- E.1 **Hearing to consider the ‘Cargill Plummer Slough Bridge Project’, which includes a Grading Permit and Structural Permit to install a clear span bridge over Plummer Slough within Cargill, Incorporated’s (Cargill) solar salt production facility at 7220 Central Avenue. The Planning Commission will consider recommending that the City Council: 1) adopt the California Environmental Quality Act (CEQA) Initial Study and Mitigated Negative Declaration (IS/MND) and Mitigation Monitoring and Reporting Program (MMRP) for the proposed project; and 2) approve the Grading Permit and Structural Permit for the Cargill Plummer Slough Bridge Project – from Assistant City Manager Grindall.** **(RESOLUTIONS - 2)** *TF*

RESPONSE TO COMMENTS ON THE DRAFT INITIAL STUDY/MITIGATED NEGATIVE DECLARATION CARGILL PLUMMER SLOUGH BRIDGE PROJECT

Subject: San Francisco Bay Regional Water Quality Control Board Comments on the Initial Study / Mitigated Negative Declaration for the Cargill Plummer Slough Bridge Project, City of Newark, Alameda County, California
SCH No. 2018062017

Figure 1.
Waters of the State
within the
Plummer Slough Bridge
Project Area
 Plummer Slough Bridge
 Alameda County,
 California

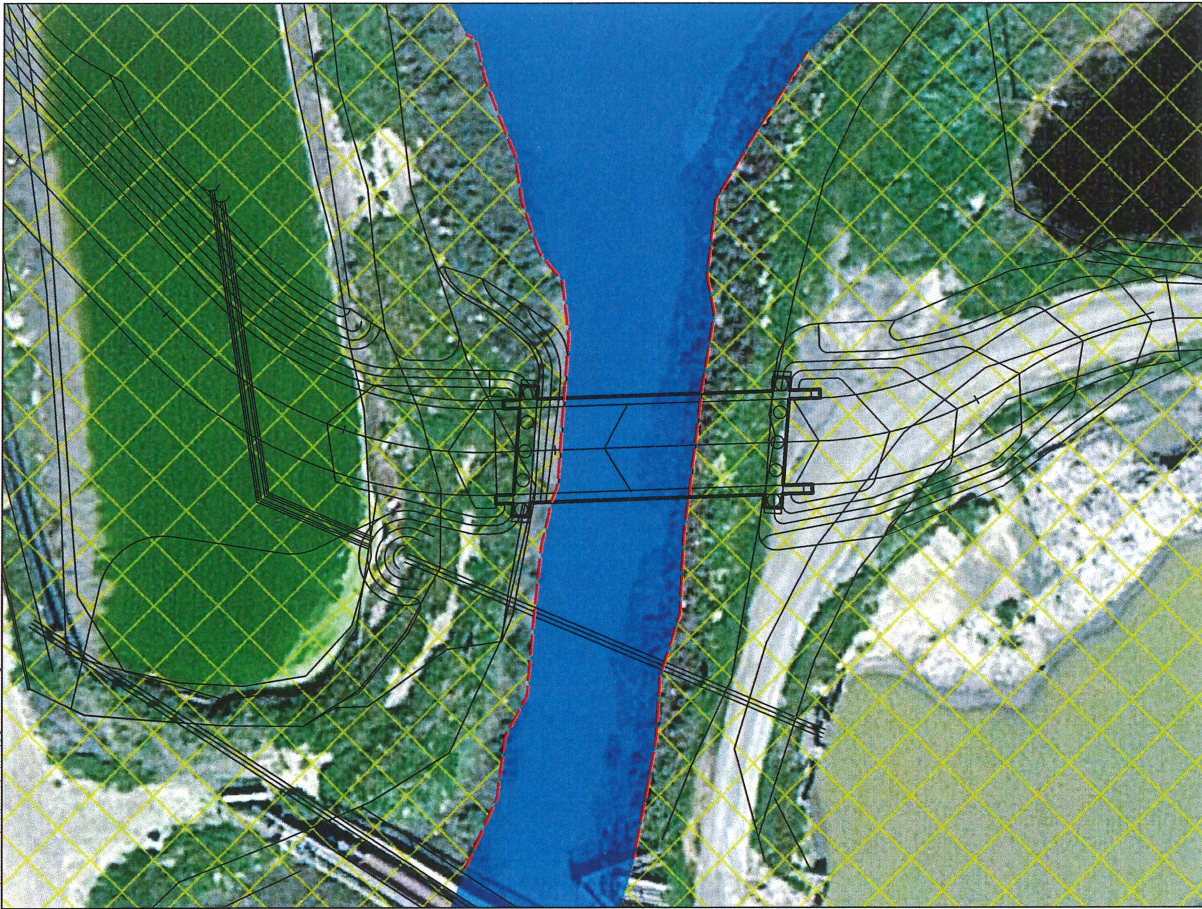
The cross-sectional view of the bridge shows a water surface elevation mark. But there is no indication of the elevation that is being referenced (e.g., ordinary high water, 10-year flood elevation, 100-year flood elevation, or high tide line). Without this information, the extent of any new fill to be placed in waters of the State, as well any potential impacts on local flooding, cannot be evaluated.

The water elevation mark shown in the cross-sectional view of the bridge corresponds to the high tide line (HTL). The HTL was determined in the field by a WRA biologist using indicators of the highest regularly occurring tide level, including a shift in vegetation from tidal to upland vegetation, and a wrack line. The attached Figure 1 shows these lines relative to the bridge abutment.

The bridge at the eastern abutment would be approximately 5 feet above the current elevation of mean higher high water (MHHW) and approximately 3.2 feet above the current 100-year flood elevation occurring concurrently with a MHHW tide level. At the western abutment, the bridge

would be approximately 4 feet above the current elevation of MHHW and approximately 2.2 feet above the current 100-year flood elevation occurring concurrently with a MHHW tide level. These elevations accommodate the existing elevations of the surrounding levees and the bridge approaches and will make the bridge functional under current operational conditions. Conclusions regarding potential impacts due to local flooding were made based on these design elevations.

Figure 2

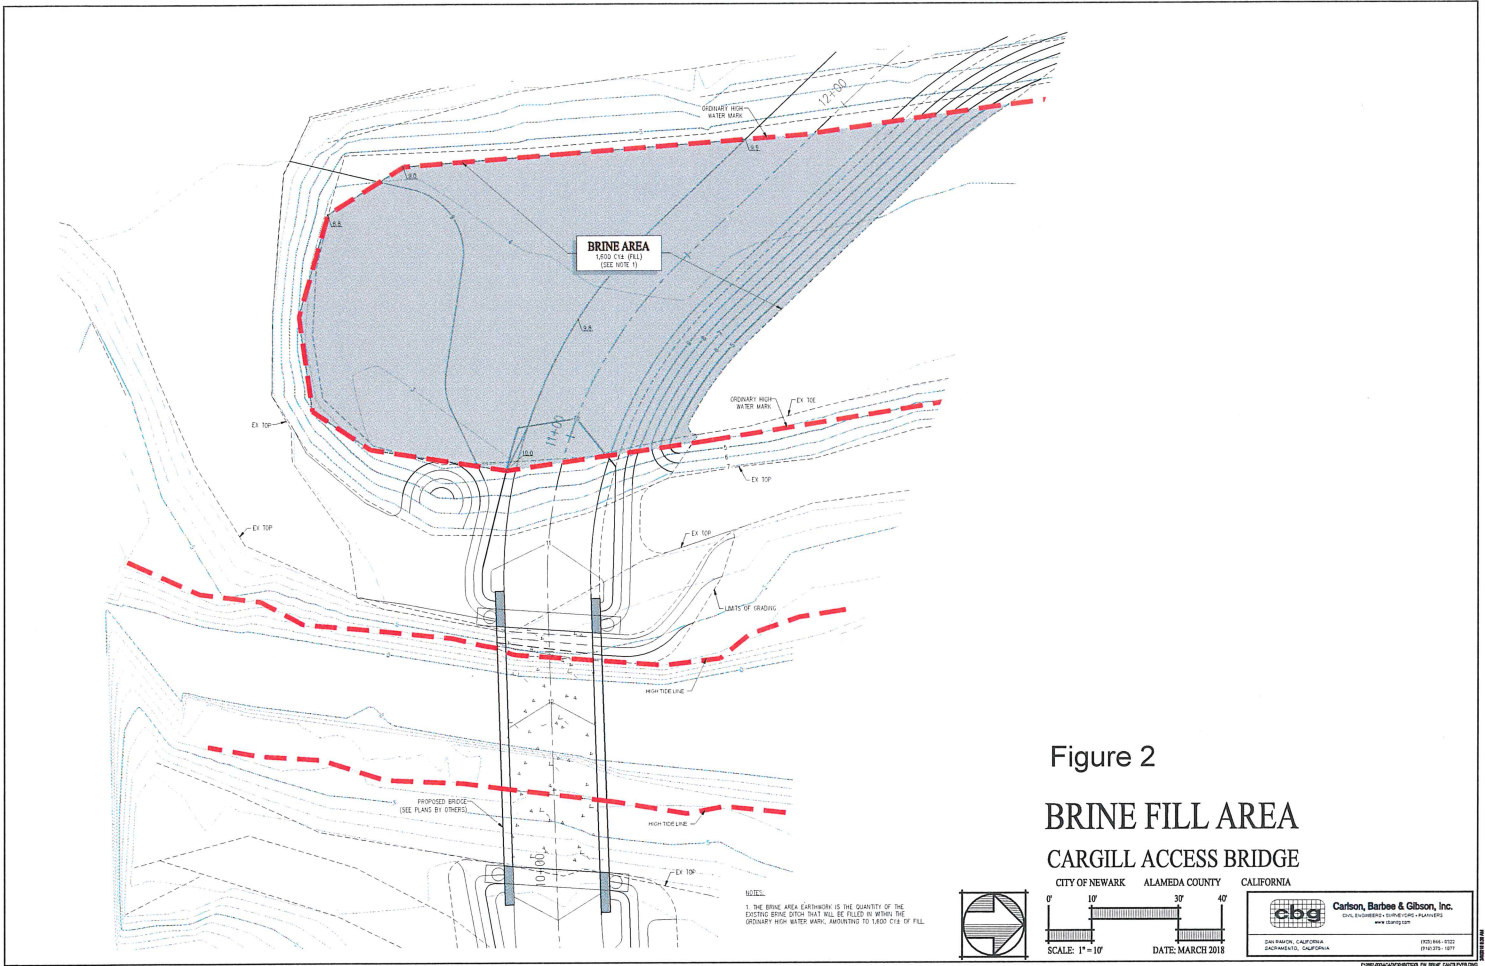
The *Design Level Geotechnical Investigation* also refers to a retaining wall that is to be constructed in a brine ditch to support fill that will be placed in the brine ditch for the new haul road. However, the location and extent of fill to be placed in the brine ditch are not clear from the information presented in the ISMND. The status of the brine ditch as a water of the State and/or water of the U.S. should be discussed in more detail, along with the extent of proposed fill

The project plans provided in the Draft Initial Study/Proposed Mitigated Negative Declaration do not propose a retaining wall through the brine ditch. The retaining wall was evaluated as part of the *Design Level Geotechnical Investigation* (Appendix B to the Draft Initial Study/Proposed Mitigated Negative Declaration), but it was removed from the plan prior to completing the Draft Initial Study/Proposed Mitigated Negative Declaration, in favor of filling the area in the brine channel (see attached Figure 2).

As noted above, the RWQCB reviewed the project plans, which included details regarding fill proposed in the brine ditch, in 2017 and determined that the project avoided RWQCB jurisdiction and a permit would not be required. The brine ditch is an operational feature that the agencies have opined are covered under the existing operations and maintenance permits. Therefore, no mitigation is proposed for filling the brine ditch.

Figure 3a Proposed Area of Mitigation for Plummer Slough Bridge

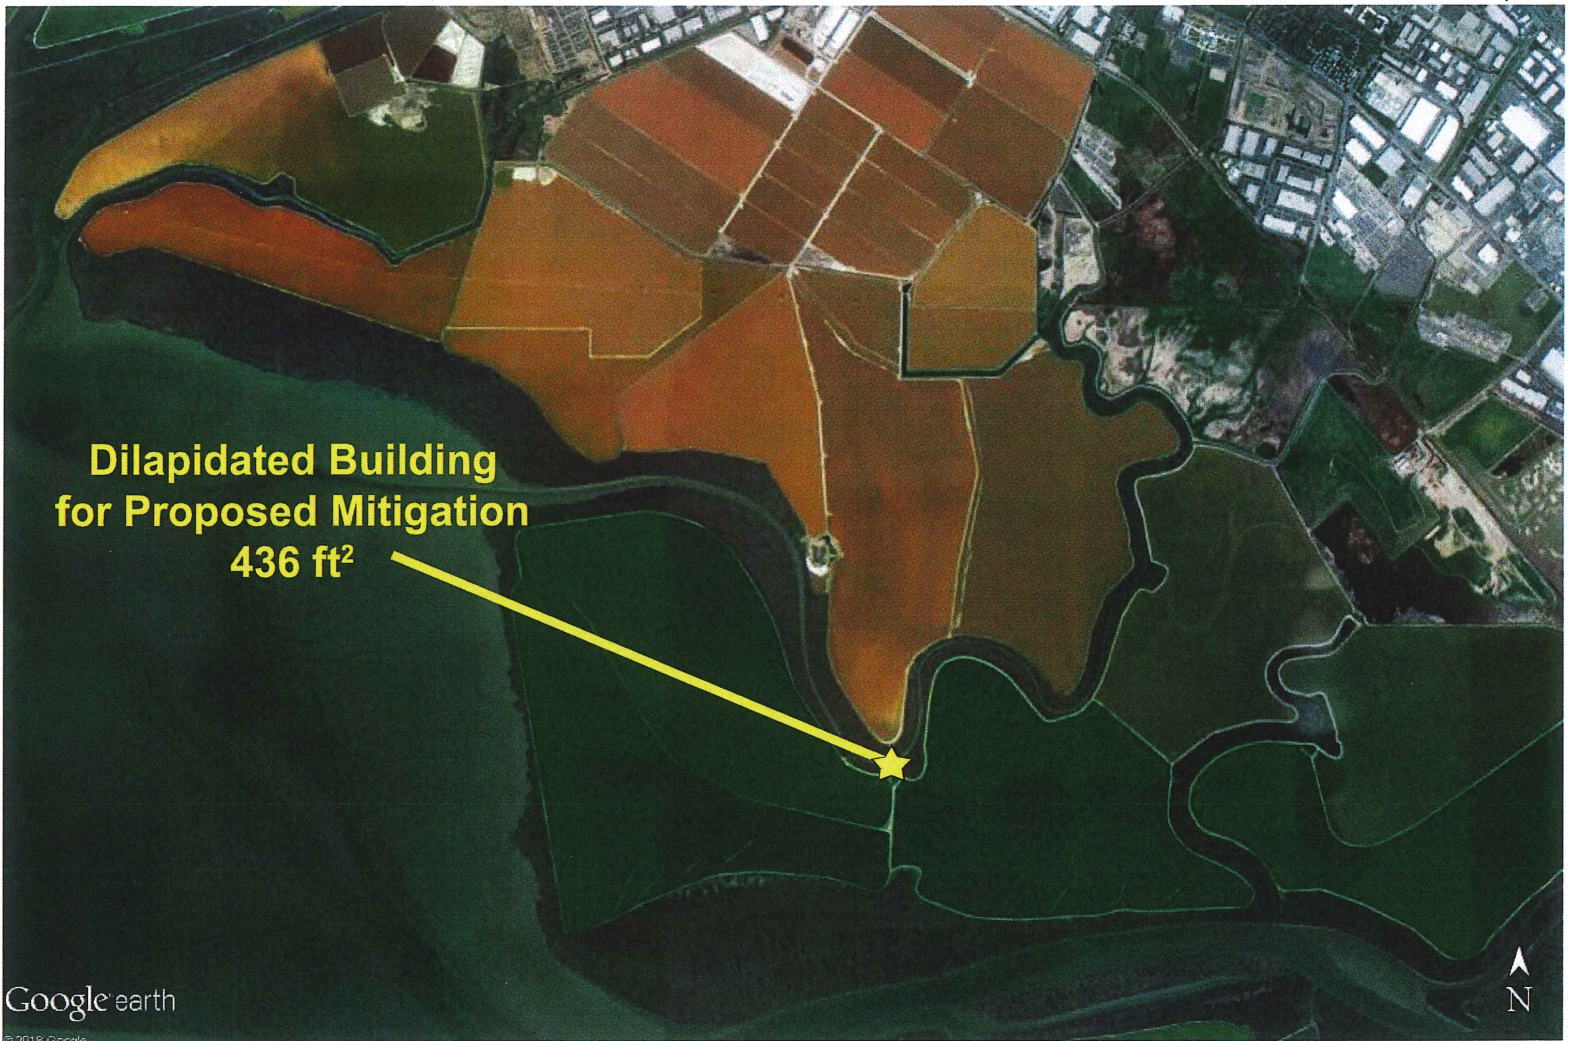
Text in the discussion of Section 4.4 b) discusses the conversion of about 391 square feet of salt marsh wetlands to open waters, as a result of shading beneath the new bridge. The ISMND proposes to mitigate for this impact to salt marsh wetlands as part of conformance with a Non-Material Amendment to the existing BCDC Permit. Mitigation is proposed at a 1:1 ratio for in-kind replacement of salt marsh wetlands. However, a mitigation location is not specified, and text in Section 4.4 b) states that other mitigation measures may be proposed to BCDC.

The ISMND should be revised to state that the Water Board may also require mitigation for impacts to salt marsh wetlands. And a proposed mitigation project should be included in the revised ISMND. In a CEQA document, a project's potential impacts and proposed mitigation measures should be presented in sufficient detail for readers of the CEQA document to evaluate the likelihood that the proposed remedy will actually reduce impacts to a less than significant level. CEQA requires that mitigation measures for each significant environmental effect be adequate, timely, and resolved by the lead agency. In an adequate CEQA document, mitigation measures must be feasible and fully enforceable through permit conditions, agreements, or other legally binding instruments (CEQA Guidelines Section 15126.4). Mitigation measures to be identified at some future time are not acceptable. It has been determined by court ruling that such mitigation measures would be improperly exempted from the process of public and governmental scrutiny which is required under the California Environmental Quality Act. The current text of the ISMND does not establish the extent of proposed impacts to wetlands and other jurisdictional waters and it does not demonstrate that it is feasible to mitigate all potentially significant impacts to waters of the State that may result from Project implementation to a less than significant level. Any future impacts to the jurisdictional waters at the Project site, as well as proposed mitigation measures or such impacts, will require review under CEQA before the Water Board can issue permits for those proposed impacts

Mitigation Measure BIO-2 requires the applicant to obtain a Non-Material Amendment to the existing BCDC Permit which shall mitigate for the loss of 391 square feet (0.009 acre) of salt marsh wetlands via in-kind replacement at a 1:1 ratio or other methods deemed acceptable by BCDC. Based on input from BCDC, potential performance standards include the possible removal of an existing duck shed or other structure in tidal marsh, and allowing the tidal marsh to recruit naturally, to restore in-kind at a 1:1 ratio.

- The total area of marsh vegetation shaded by the project is approximately 390 square feet. As mitigation for those shading impacts, Cargill is proposing to remove a building that is shading approximately 436 square feet of salt marsh vegetation located within Cargill property. Salt marsh is expected to recruit naturally once the structure has been removed, resulting in a gain of approximately 436 square feet of marsh (net gain of 46 square feet, considering impacts). Figure 3 shows the location of the structure to be removed and photographs of the area of structure and surrounding salt marsh. Marsh vegetation in the area of the structure removal is of similar composition to the marsh vegetation (mid/high marsh) being shaded by the proposed bridge.
